# CHABOT-LAS POSITAS COMMUNITY COLLEGE DISTRICT PURCHASING DEPARTMENT

## Addendum No. 2

### REQUEST FOR PROPOSAL BID: B23/24-06 Erosion Control Project at Las Positas College

SHEET  
**C3.0**  
OF SHEETS

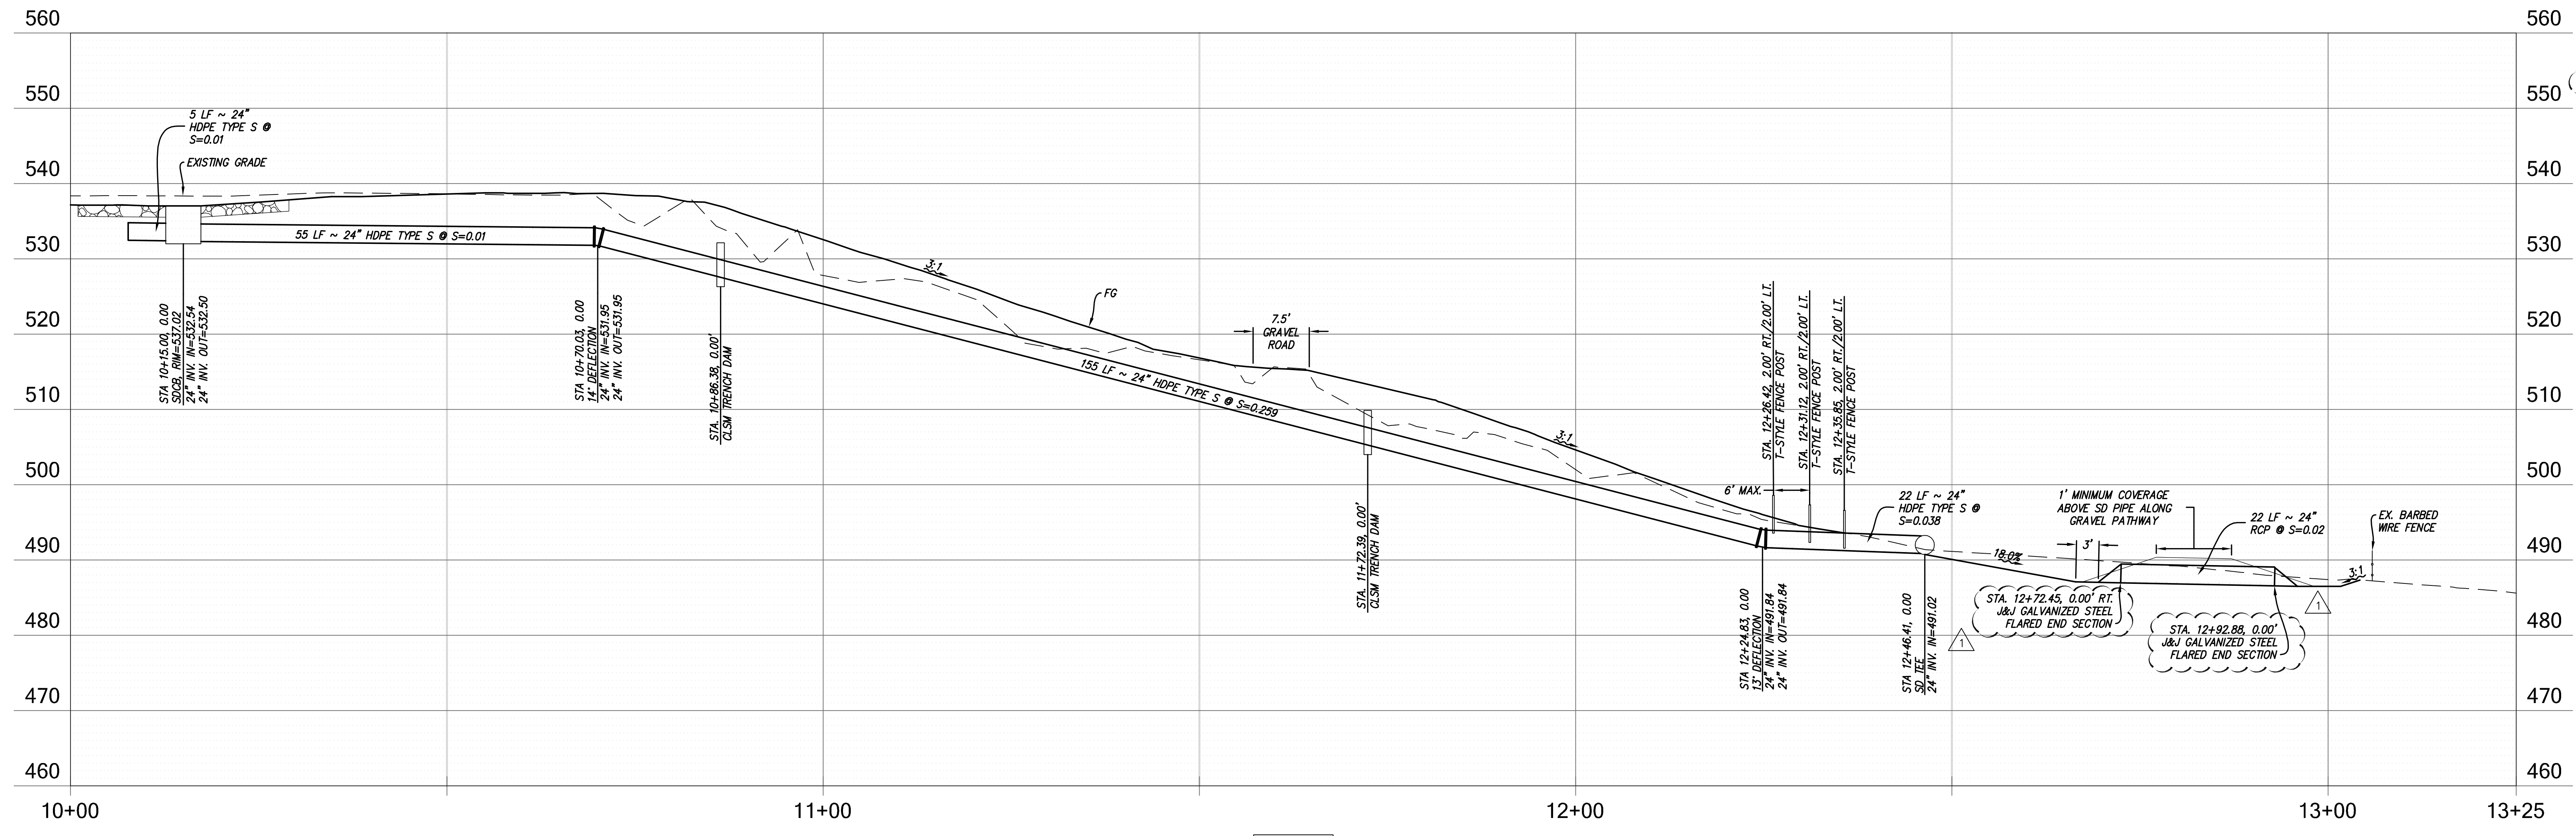
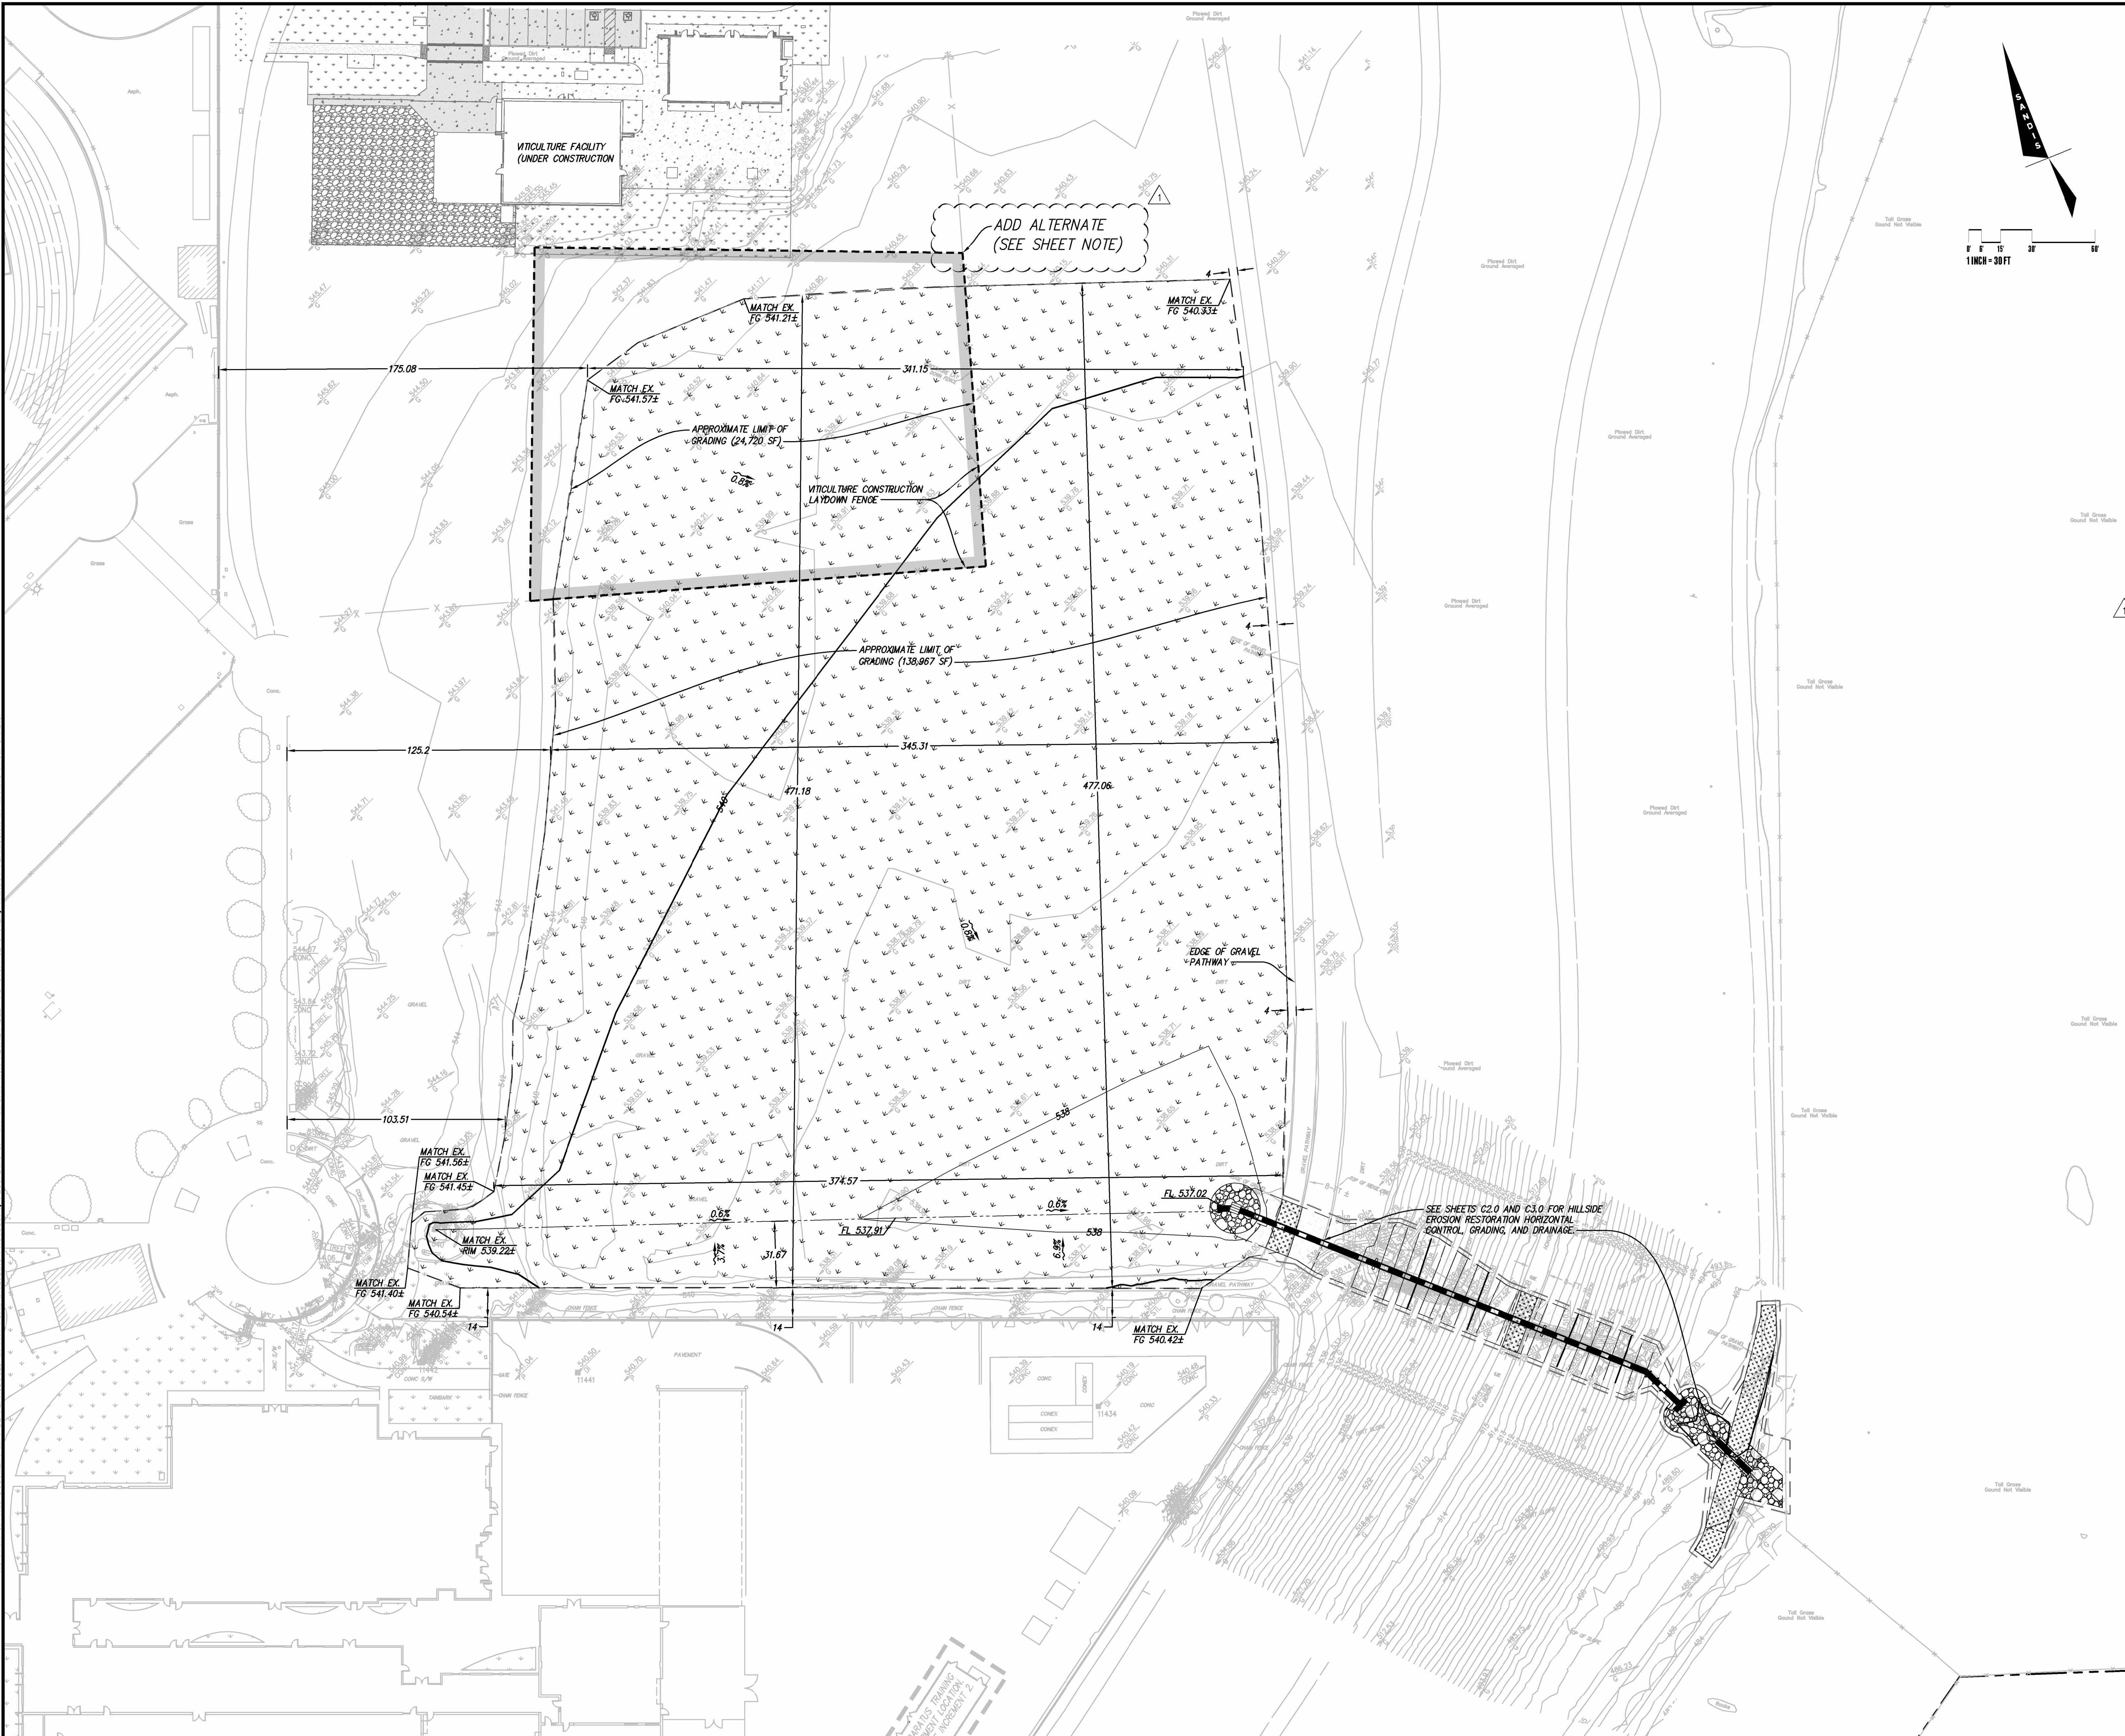
8. **Sheet C3.0 – Grading and Drainage Plan:** Revised call out notes for SD Inlet #2 and SD Outfall #2. Revised Sheet Note 1 under Storm Drainage Notes.
9. **Sheet C3.1 – Rough Grading Plan:** Enlarged Add Alternate call out note. Revised Add Alternate Description Sheet Note states “Coordination is required with Viticulture Building Project for regrading of area to provide positive drainage towards proposed drainage inlet”.
10. **Sheet C5.0 – Sediment and Erosion Control Plan:** Revised indicator for the Hydroseed areas as to not conflict with indicator for road areas.
11. **Sheet C5.1 – Sediment and Erosion Control Plan:** Revised indicator for the Hydroseed areas as to not conflict with indicator for road areas.

**Question No. 13:** The plans show 24" HDPE Type S pipe and fittings for the upper run of storm drain but there is some confusion on what the second run is made of. The flared ends are called out as ADS but the pipe is called out as RCP on sheet C3.0. Note 1 on sheet C3.0 says all pipe materials and fittings to be HDPE M294 Type S. Detail 4 on sheet C4.0 calls the pipe 24" SD. The storm drain piping spec says HDPE is acceptable for non-vehicular areas ONLY. Please clarify if the 24" pipe under the lower road/pathway is HDPE or RCP?

**Question No. 28:** Please provide more information for the SD inlet #2 and outfall #2. Are these supposed to be metal Flared End Sections or precast?

**RESPONSE:** The pipe under the lower gravel road is RCP to accommodate vehicular loading. See section A.8 above for clarity.

**RESPONSE:** Per Revised Sheet C3.0 included in addendum 2, inlet #2 and outfall #2 shall be J&J Galvanized Steel Flared End Section with Smooth Tapered Sleeve Adapter or approved equivalent.

**RESPONSE:** Correct. Per Note #3 on Sheet C3.0, the intent is to balance site grading in the final condition.
